Re: Cobbora Coal Project (MP 10_0001) – project update

This letter is to inform the Department of Planning and Infrastructure of changes to the Cobbora Coal Project (the Project) (MP 10_0001) since the submission of the *Cobbora Coal Project, Project Update Report* on 22 August 2011. These changes have been introduced to generally avoid or minimise environmental impacts that have been identified as part of the ongoing environmental assessment.

Project Application Area
Cobora Coal Project

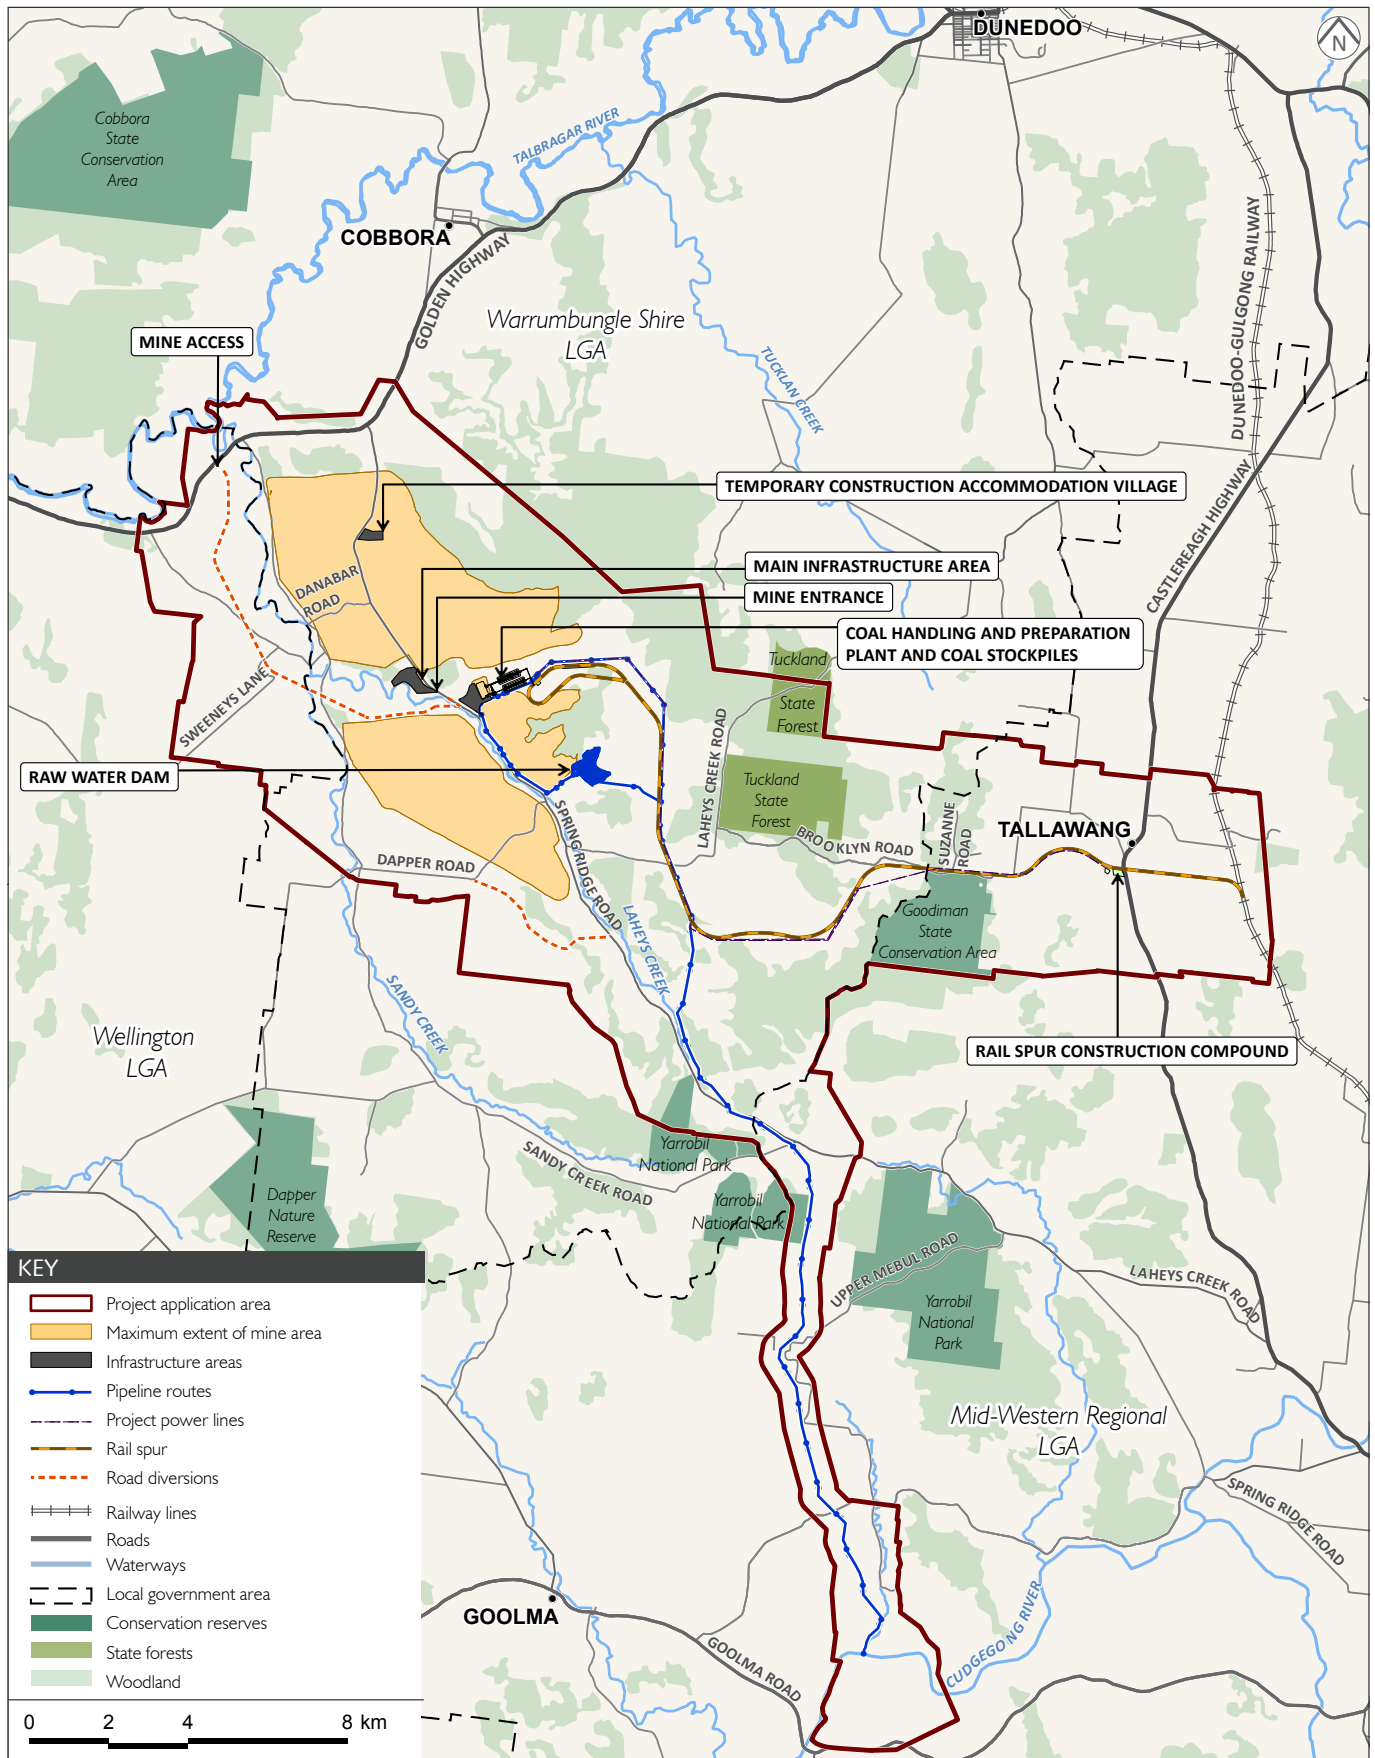
An updated project layout is provided in the attached figure.

It is no longer proposed to build this conveyor. Instead, the rail spur will extend from the Dunedoo-Gulgong rail line to the CHPP that will be adjacent to the mine area. The proposed rail spur will be approximately 28 km long, including the balloon loop. The rail spur will pass largely through cleared agricultural areas (Agricultural Suitability Class 3 and 4). It will be constructed on land owned by Cobbora Holding Company Pty Limited.

The CHPP and associated coal stockpiles have been moved approximately 1 km to the east to be adjacent to the rail loop. This is further from the banks of Laheys Creek.

It is proposed to construct a Spring Ridge Road diversion that will join Spring Ridge Road to Sweeneys Lane and to realign the northern section of Sweeneys Lane to improve access to the Golden Highway. A road realignment will also be required south of Suzanne Road to accommodate the rail spur.

The indicative route of the water pipeline from the Cudgegong River has been refined to minimise archaeological impacts and to avoid unavailable land.

The Project Application Area provided in the *Cobbora Coal Project, Project Update Report* (August 2011) has been modified to ensure that the road diversions, rail spur and water pipeline are contained within this area, increasing it from 246 km² to 274 km².
